### PLANNING COMMISSION REGULAR DOCKET TUESDAY, February 14, 2012 – 5:30 P.M. CITY COUNCIL CHAMBERS

**APPLICATION FOR APPROVAL OF  
PRELIMINARY SITE PLAN**

ARLINGTON AND MILLMONT APARTMENTS  
 PREPARED FOR  
 PEAK CAMPUS DEVELOPMENT, LLC

SHEET NUMBER  
**CV-100**

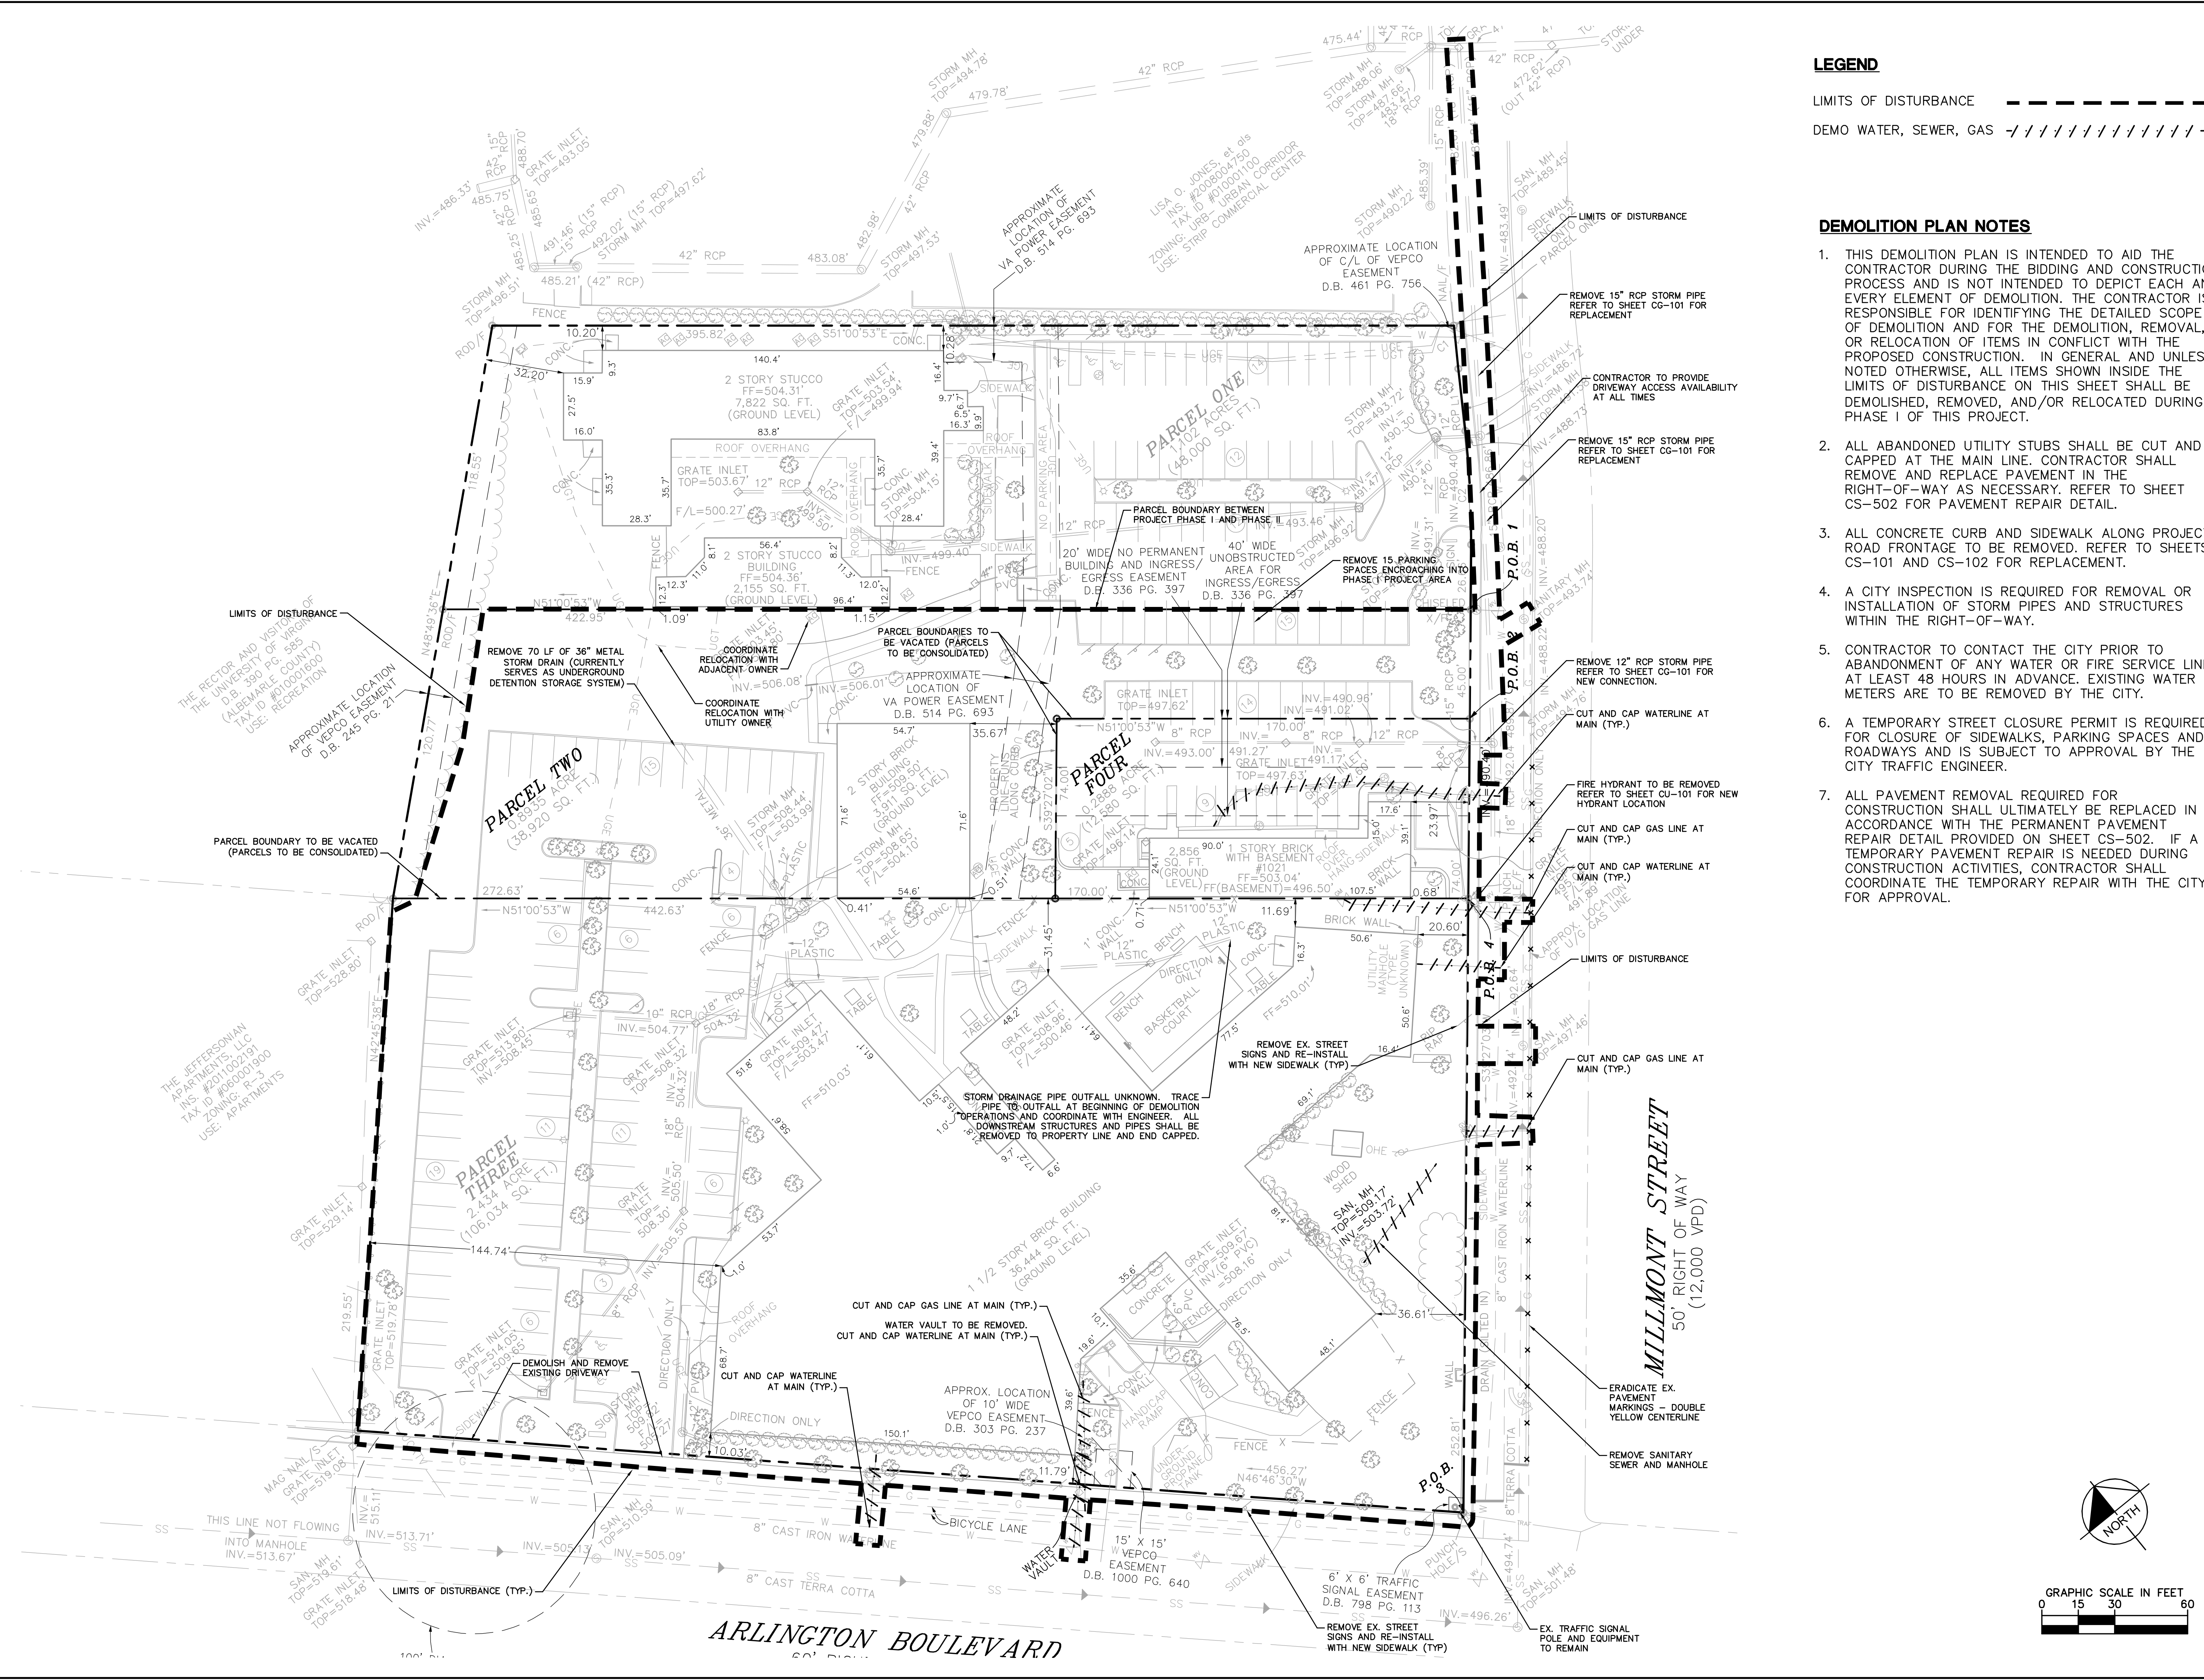
1. I cannot see the lot lines or boundary dimensions on the existing conditions page clearly, please clarify. That existing conditions page is a bit cluttered.  
**Response: Parcel boundaries have been clarified on CV-100.**
2. The sidewalk at the corner of Arlington and Millmont should have a CG-12.  
**Response: CG-12 sidewalk ramps have been identified at the corner of Arlington and Millmont on sheet CS-101.**
3. Remove engineering signature panel

**Response: Tree caliper and type are provided on sheet CV-100. All trees greater than 6" in caliper were assigned a number and listed in the table provided in the upper right corner of the sheet.**

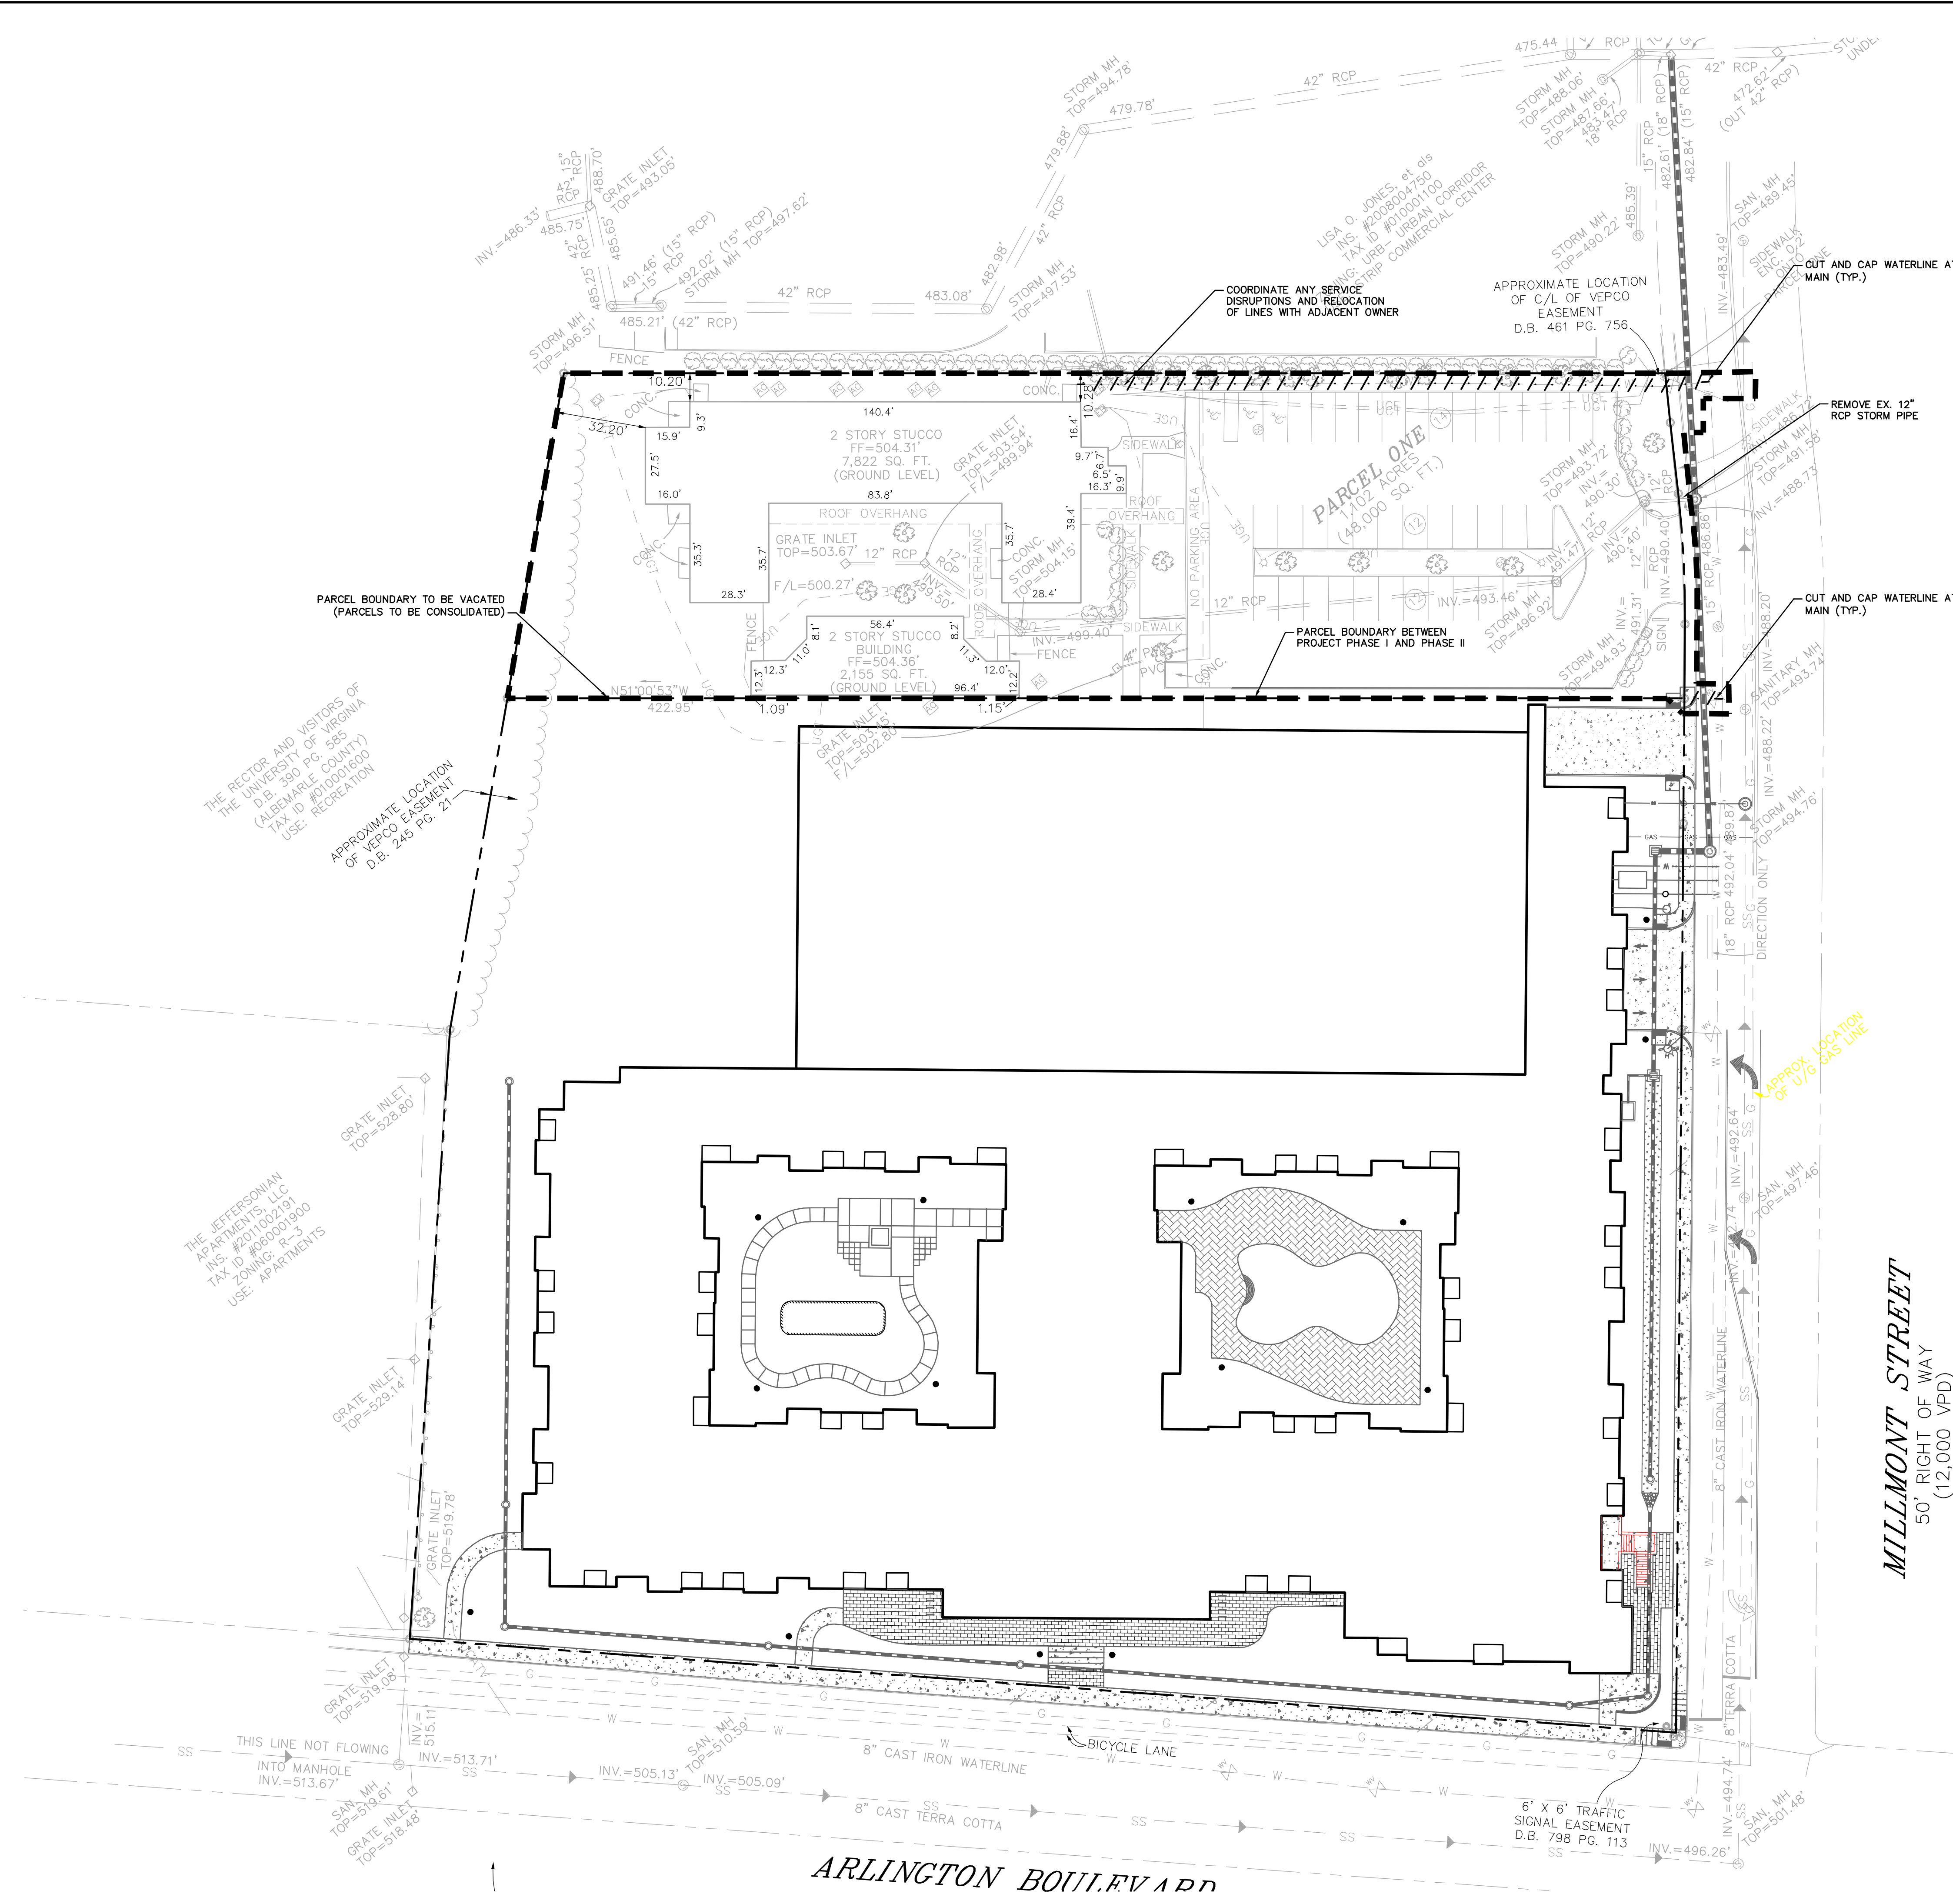
1. Demolition note #2 references sheet CS-502 for pavement repair detail. Please distinguish between permanent and temporary pavement repair on the plans.

4. The existing water vault on Arlington is to be removed. Please label as such.  
**Response: A note specifying removal of the water meter vault has been added to sheet CD-101.**

**Response: Note #5 has been added to sheet CD-101 with the specified removal requirements.**

**Response: The existing sanitary sewer manhole and lateral piping have been noted for removal on sheet CD-101.**

**Response: All pavement repair shown on the plans will ultimately be a permanent repair, however during the course of construction there may be times when a temporary repair is necessary (i.e. work stoppage at end of day, temporary patch for pedestrian access, etc.). A note has been added to sheet CD-102 noting that all pavement repairs shall ultimately follow the permanent pavement repair detail on sheet CS-502 but to coordinate with City inspectors if a temporary repair is needed during construction.**

**Response: Sheet CD-101 has been revised to callout the proposed cut and cap of existing gas service lines to the buildings scheduled for demolition.**
